Historic District Commission

COA-2024-04, Mod. 1 – 33 Center Street – Rooftop Solar Energy System

Request:
Applicant Simon Gray of Green Energy Options, on behalf of owner William Brown, proposes to install a 16 panel rooftop solar energy system to the existing ~1,156-sf building located at 33 Center St (TMP #568-015-000). The parcel is 0.10-ac in size and is ranked as a Contributing Resource in the Downtown Transition District.

This application proposes to install a 16 panel rooftop solar energy system on to the south facing, asphalt shingle, roof surfaces. The project will include panels on the second story main roof and the third story dormer.

Fig 2: Southern elevation of 33 Center St.

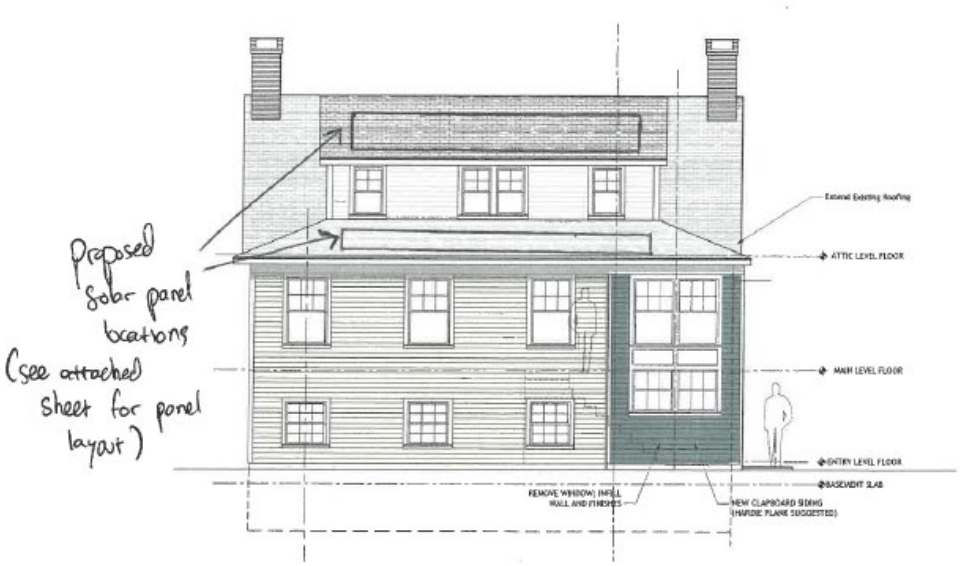
The applicant states in their narrative that the proposal is the least obtrusive by utilizing dark-colored panel cells that are installed flush with the roof to blend in with the dark colored asphalt roofing shingles. Supplementary components and supply lines will also be hidden. It appears that this standard has been met.

Fig 3: Panel Layout

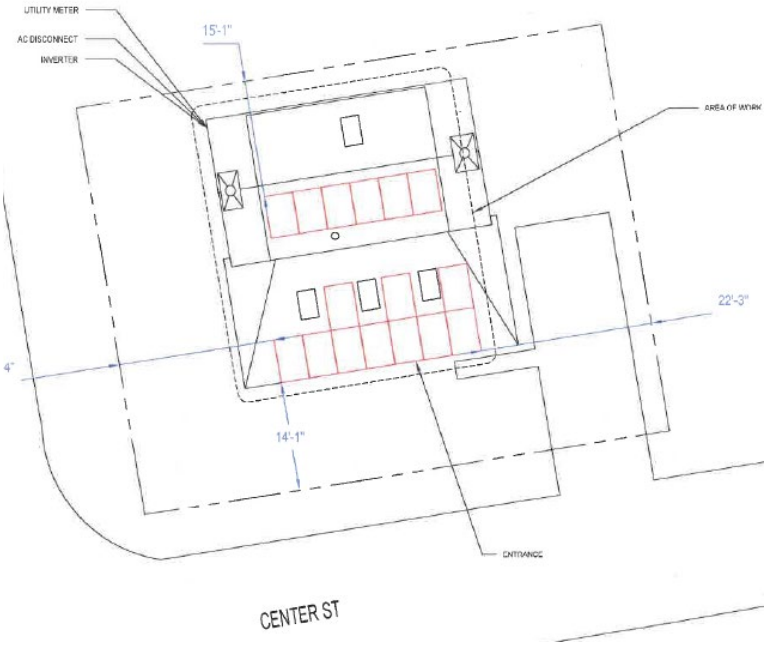
The applicant states in their narrative that the panels will be installed in a regular shape with straight columns and rows. The proposed layout considers existing sky lights on the roof. The Board will need to determine if this standard has been met.
